1959 - 1960 Corvette: Service Bulletin: Front and Rear Door Glass Loose in Run Channels

Source: Chevrolet Technical Service Bulletin

Bulletin No: DR #651

Date: April 7, 1960

FIGURE #1

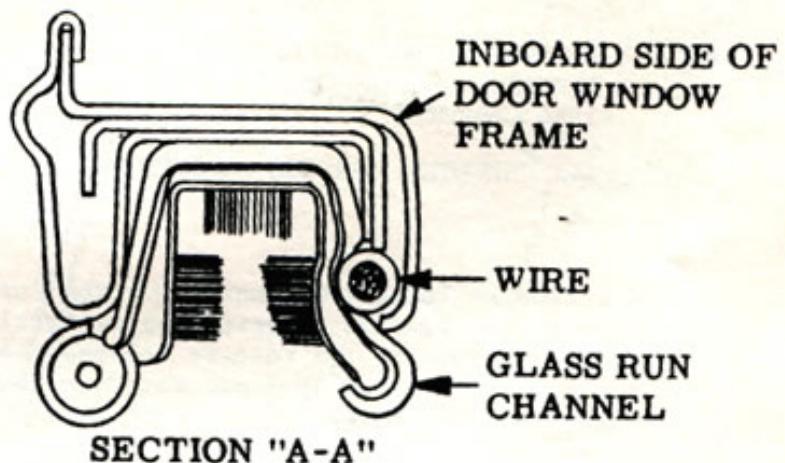
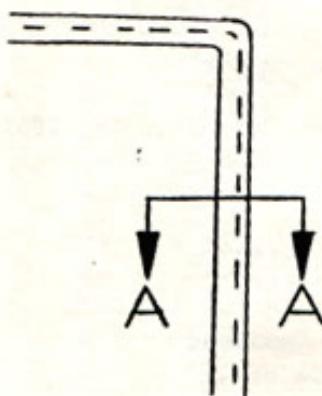
The condition of "in and out" looseness may be corrected by installing black insulated wire or similar material between the glass run channel and the inboard side of door window frame as shown in Section "A-A", figure #1. Wire should be approximately 15" long. Insert wire from belt line to top of window frame. Trim off excess wire as required.

The degree of "in and out" movement of the door window will determine the gauge of wire necessary to correct this discrepancy; however, a #14 gauge wire will normally correct the condition. On doors where the "in and out" movement of the window is very small, #20 gauge wire may be adequate.

If glass is still loose, a second piece of wire may be inserted between the channel and outboard side of window frame.

On front doors, the repair may be performed along the door lock pillar section only. However, on rear doors, the repair may be performed along either lock pillar or hinge pillar sections, or both, depending upon severity of condition.
